Vermont Agency of Transportation
RECEIVED
MARLBORO BRF 010-1(43) Temp Bridge Submittal_review.pdf

RESUBMIT Yes Rejected

PLAN OF TEMPORARY BRIDGE, ABUTMENTS & BYPASS ROAD
BRF 010-1(43)
ROUTE 9
MARLBORO, VT

ABUTMENT DETAILS 1" = 2'

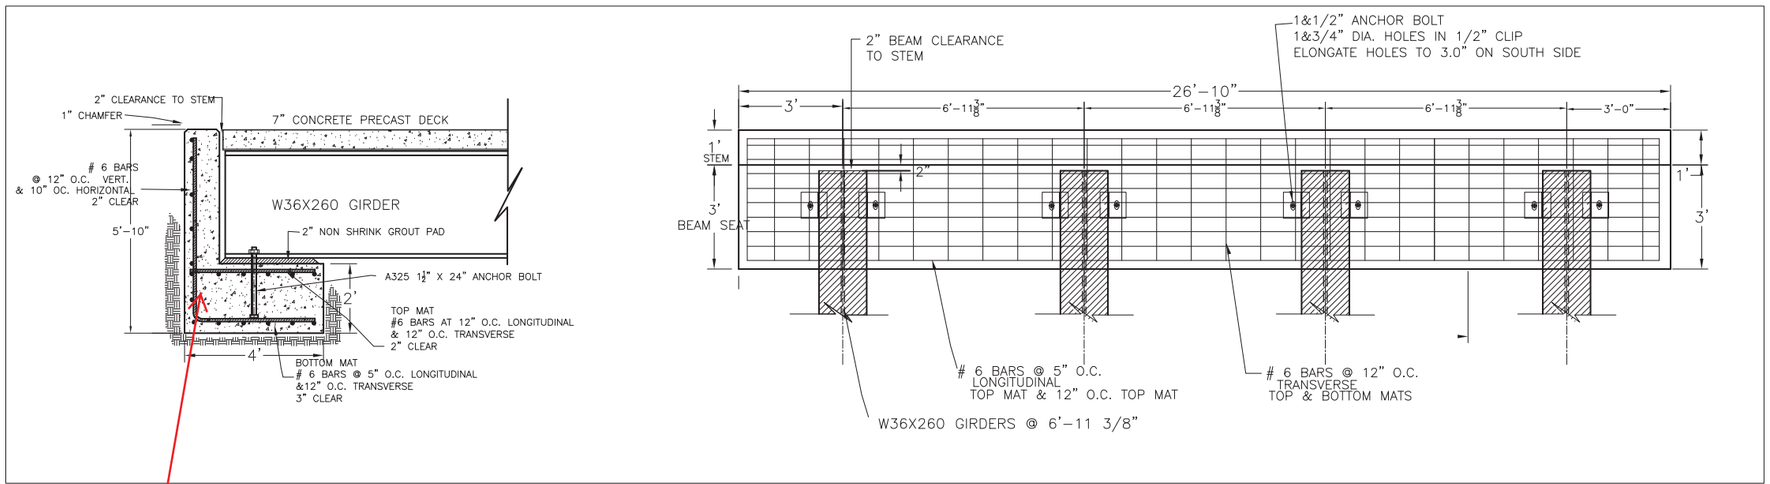
Provide abutment material notes

Provide Bridge seat elevations and bottom of substructure elevations.

Is this going to be built in one piece as shown?

TYPICAL DETOUR ROAD SECTION

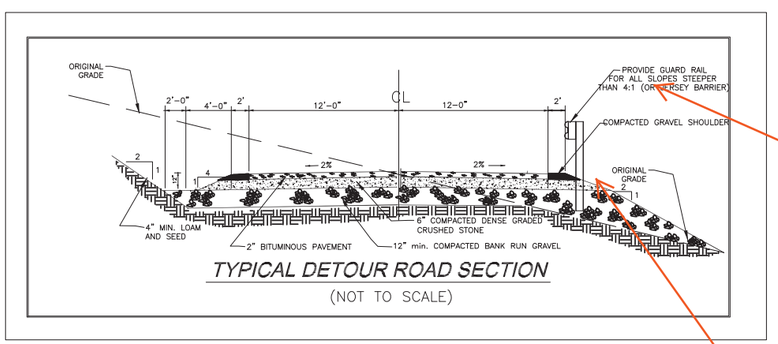
Provide w-beam guardrail dimensions (height of rail, post length, post section, etc.) and jersey barrier dimensions if used.

Verify that adequate buffer is provided for guardrail system.

BRIDGE FRAMING PLAN
NOT TO SCALE

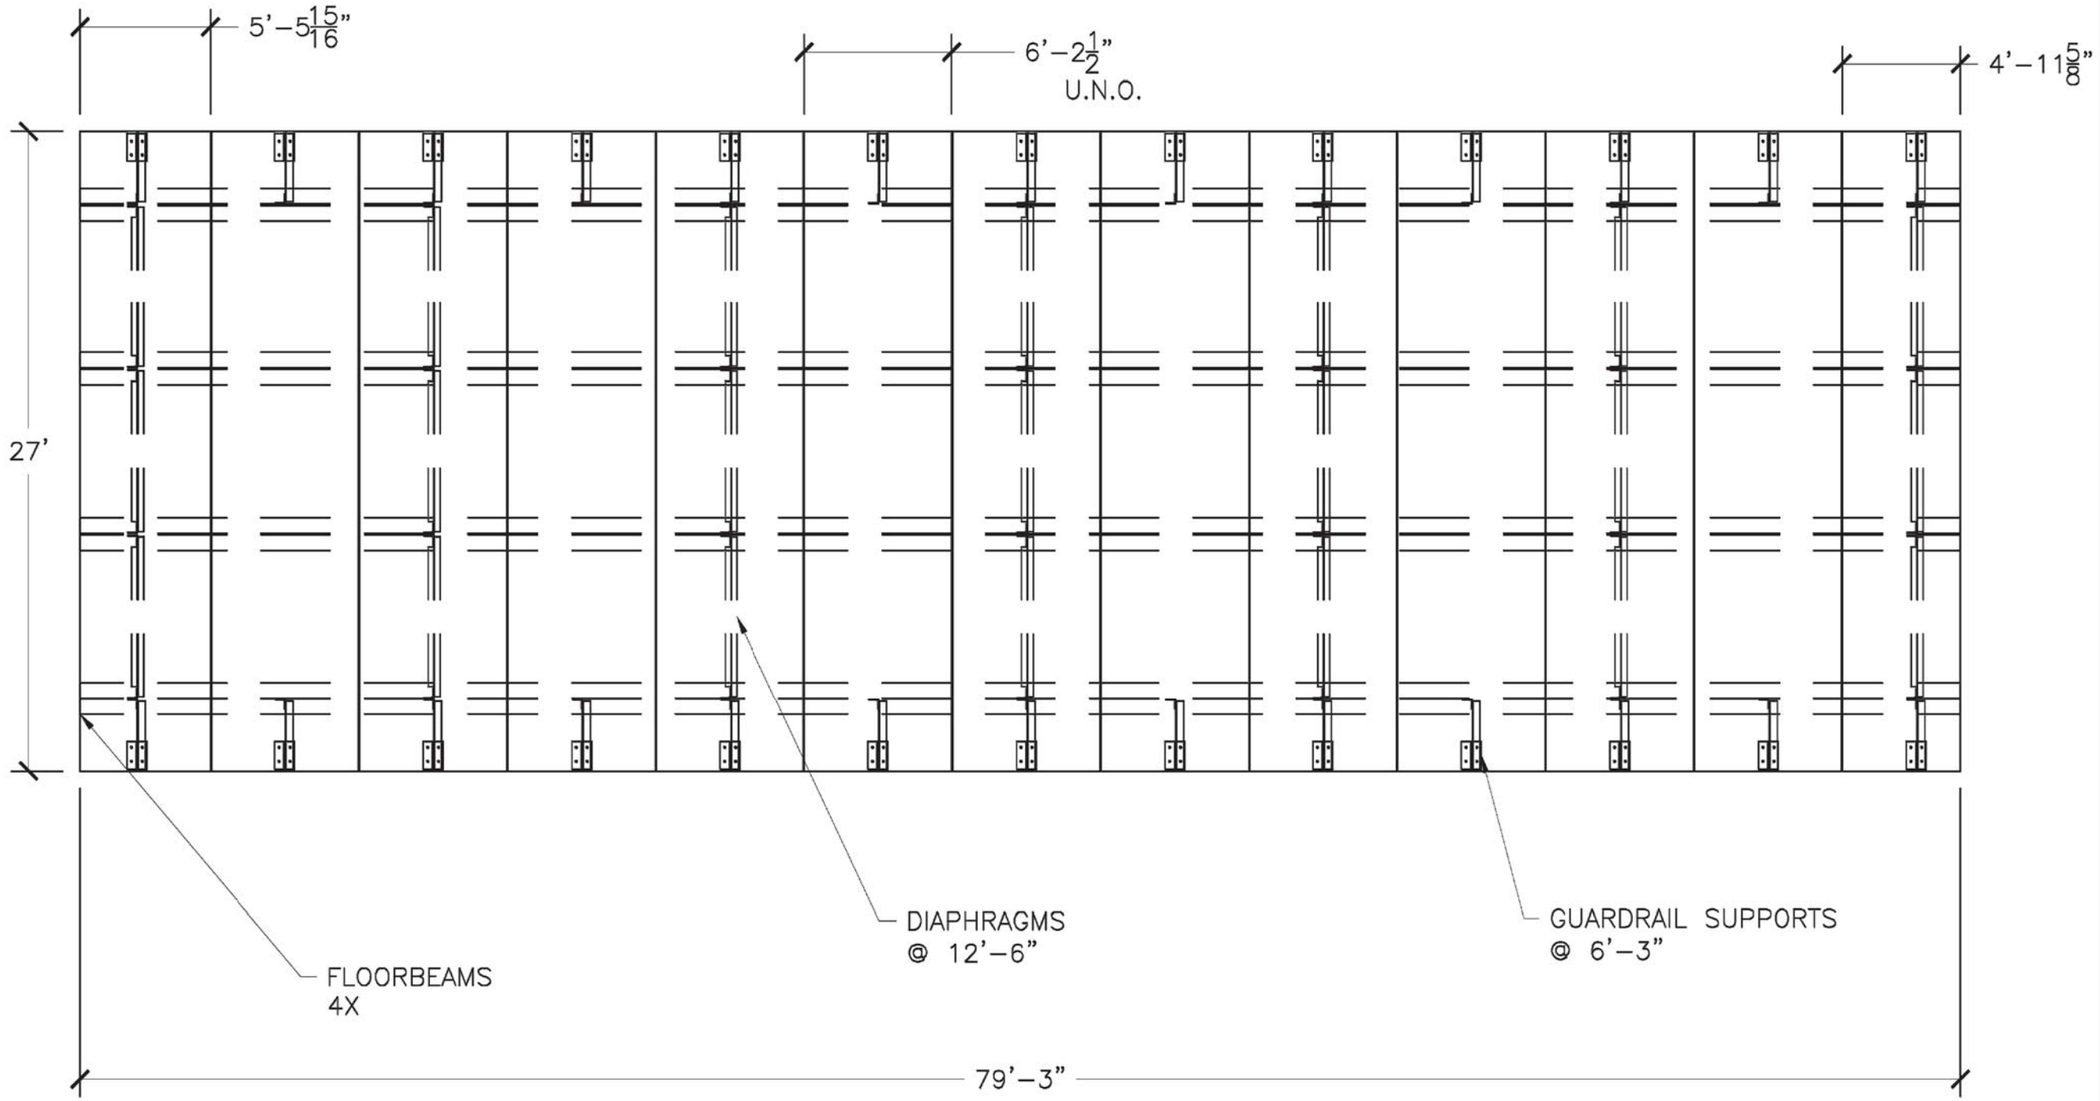
Provide connection details for precast slabs.

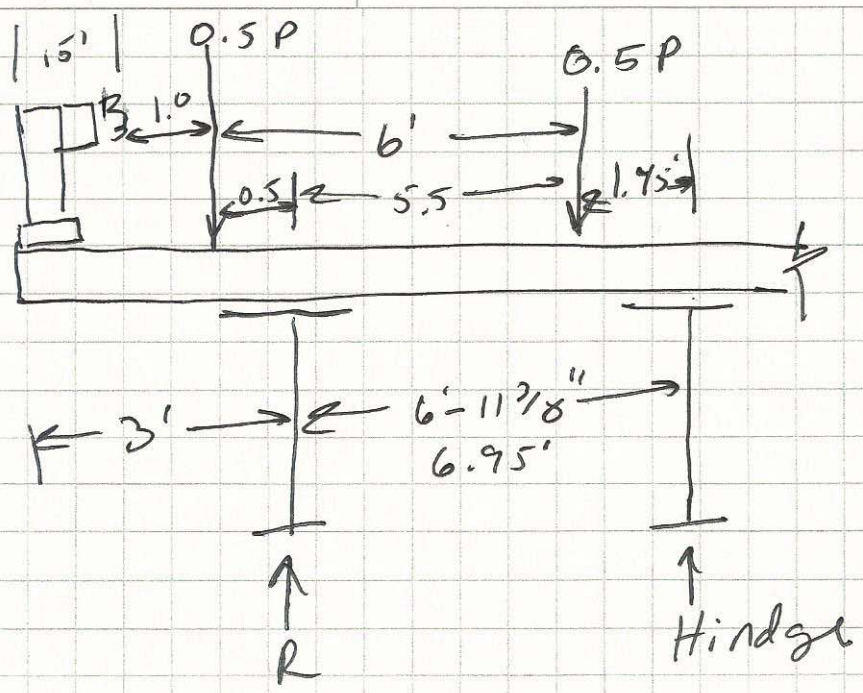
Why are the axle loads (P) divided by 2 here? The applied load for the Lever Rule calculation is already half of the axle load (0.5*P).

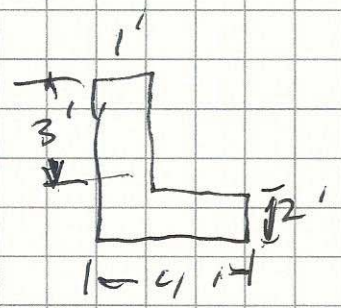
Verify that the appropriate load factor is applied to dead loads per AASHTO Tables 3.4.1-1 and 3.4.1-2

Verify that the appropriate resistance factor is applied to bearing resistance per AASHTO Table 10.5.5.2.2-1

Bearing Capacity for a Footing on Granular Soils

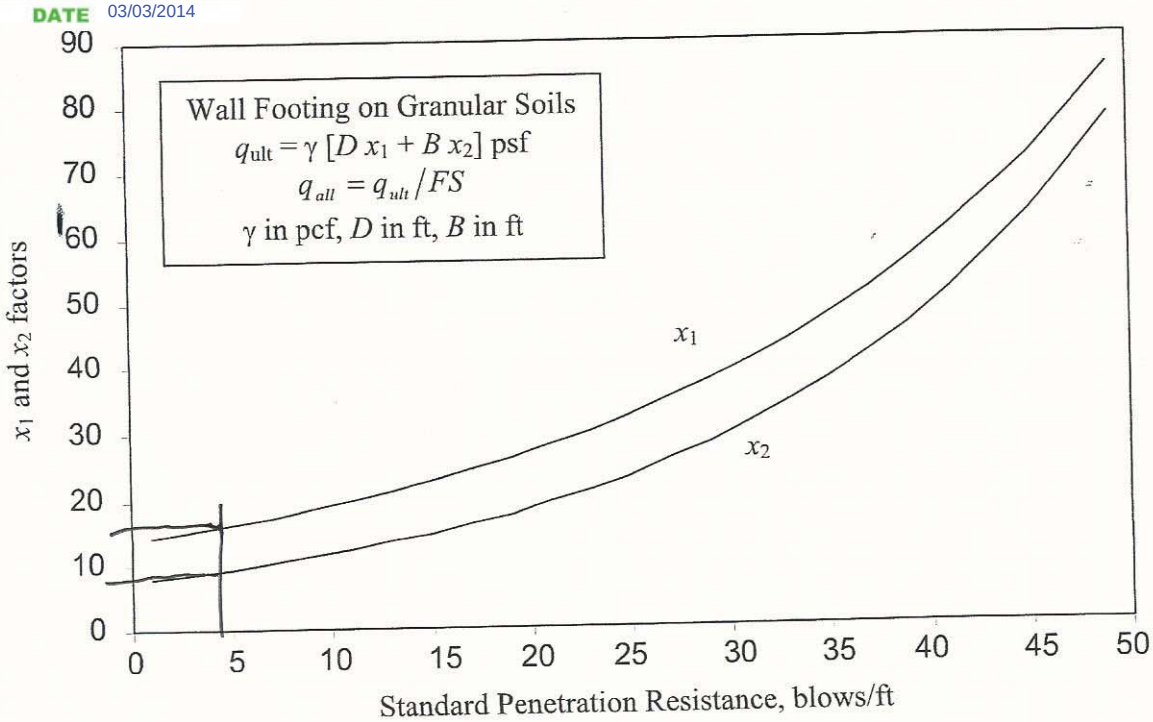
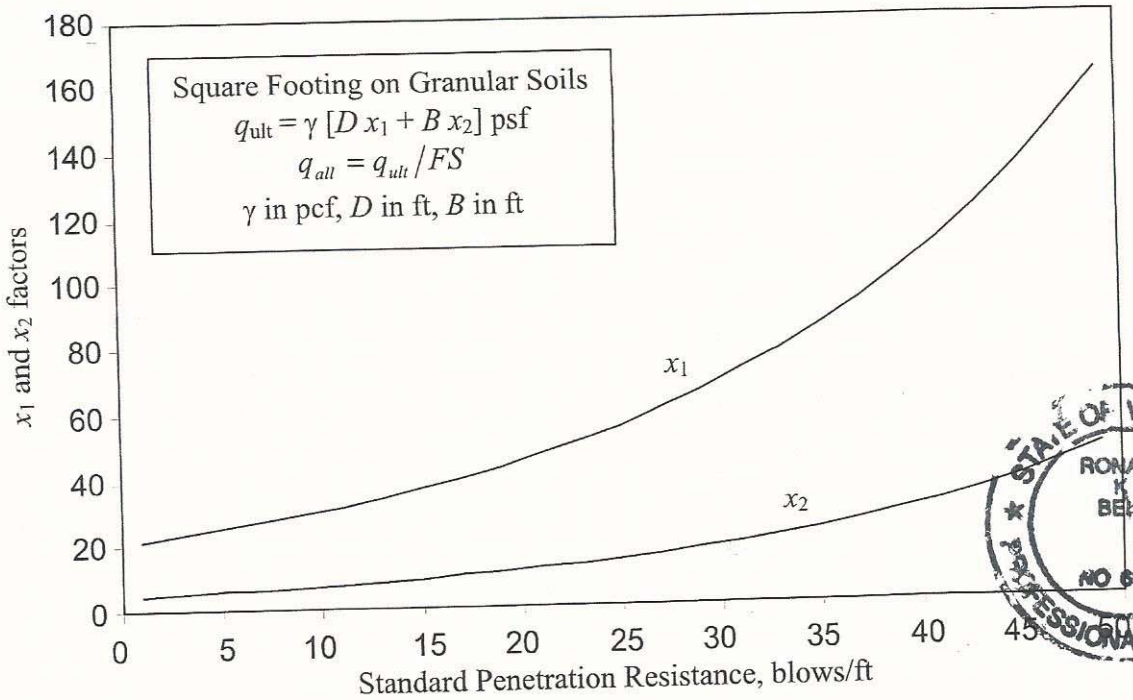
This seems high compared to AASHTO C10.6.2.6.1-1 based on soil classification and density listed for B-102 and B-104 on the boring logs. Please verify.

CHECK REINFORCEMENT

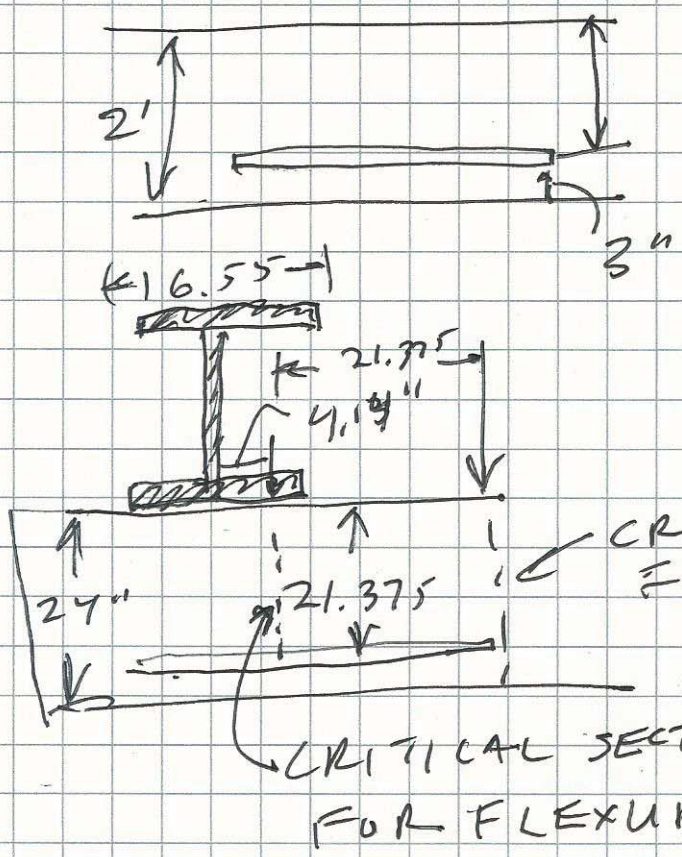
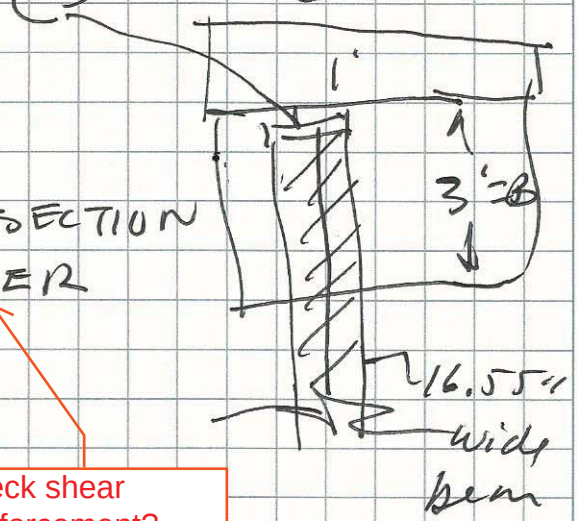
Check shear reinforcement?
